P&Z CASE # 22019-021 P&Z DATE 10/9/19 CC DATE 10/21/19 APPROVED/DENIED \_\_\_\_\_  
ARCHITECTURAL REVIEW BOARD DATE \_\_\_\_\_ HPAB DATE \_\_\_\_\_ PARK BOARD DATE \_\_\_\_\_

**Case Number:** Z2019-021  
**Case Name:** Amendment to PD-79  
**Case Type:** Zoning  
**Zoning:** Planned Development District  
**Case Address:** East of John King & South of FM 552

CONCEPT PLAN  
**SADDLE STAR SOUTH**  
70.408 ACRES SITUATED IN THE  
P.B. HARRISON SURVEY, ABSTRACT No. 97  
CITY OF ROCKWALL  
ROCKWALL COUNTY, TEXAS

## City of Rockwall Project Plan Review History

EXHIBIT B  
CONCEPT PLAN

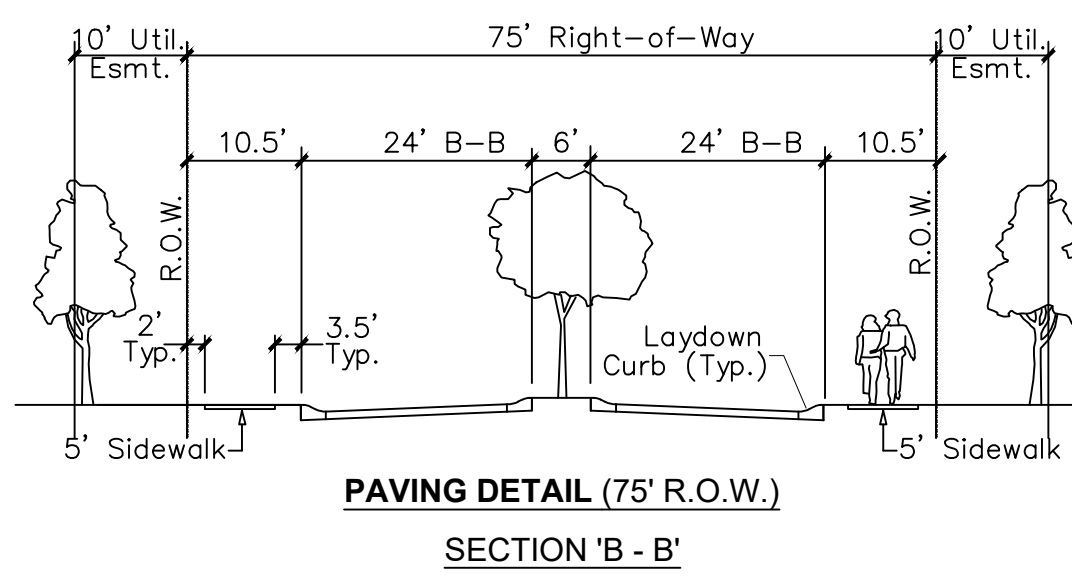
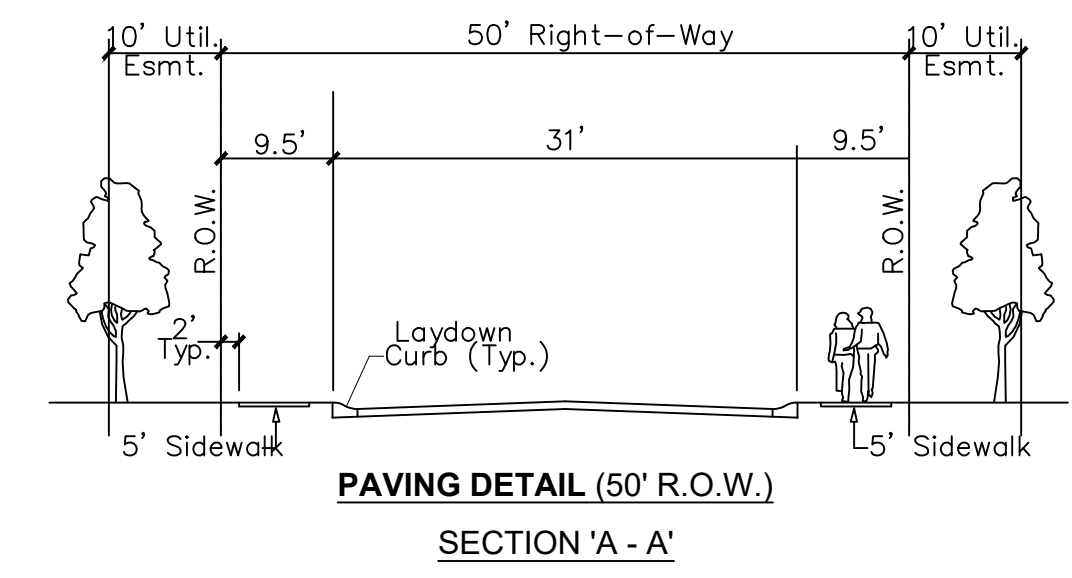
| Type of Review / Notes  | Contact          | Sent      | Due       | Received  | Elapsed | Status   | Remarks      |
|---|------------------|-----------|-----------|-----------|---------|----------|--------------|
| ENGINEERING<br>(9/20/2019 12:02 PM SJ)<br>I - 16" water line to be installed along John King frontage (Water Master Plan)<br>I - Drainage and deten. on easements to be maintained by the HOA.<br>I - Per the Stoney Hollow Li Station report dated 4-22-2019, phase 3 will overload the li s taon .<br>I - Root barriers are required for trees in roadway medians.<br>I - 4% Engineering Fee<br>I - Impact Fees<br>I - Retaining walls 3' and over must be engineered. all retaining walls to be rock or stone face. No smooth concrete walls.<br>I - Cul-de-sac to have a 47.5'R paving and 57.5'R for ROW.<br>I - Must have Detention. Manning's C-valve is per zoning. Drainage basins with 20 acres or more must use the unit hydrograph method. Review fees apply.<br>I - Site plan - Must show exisng /proposed water and sewer<br>I - Stoney Hollow Li St ation pro-rata<br>I - Need right to serve letter water release from Mt.Zion ph2 and ph3. | Sarah Johnston   | 9/13/2019 | 9/20/2019 | 9/20/2019 | 7       | APPROVED | Comments     |

| Type of Review / Notes  | Contact | Sent | Due | Received | Elapsed Status | Remarks |
|---|---------|------|-----|----------|----------------|---------|
| M.6 Provide staff with an updated Concept Plan and make changes to the Land Use Data Table indicating the changes per the draft ordinance regarding the number of lots for the development, density of dwelling units per acre (i.e. du/ac), and the percentage & acres of open space provided.   |         |      |     |          |                |         |

- 4% Engineering Fee
- Impact Fees
- Retaining walls 3' and over must be engineered. all retaining walls to be rock or stone face. No smooth concrete walls.
- Cul-de-sac to have a 47.5'R paving and 57.5'R for ROW.
- Must have Detention.
- Manning's C-valve is per zoning. Drainage basins with 20 acres or more must use the unit hydrograph method. Review fees apply.
- Site plan - Must show existing/proposed water and sewer
- Stony Hollow Lift Station pro-rata
- Need right to serve letter water release from Mt.Zion ph2 and ph3.
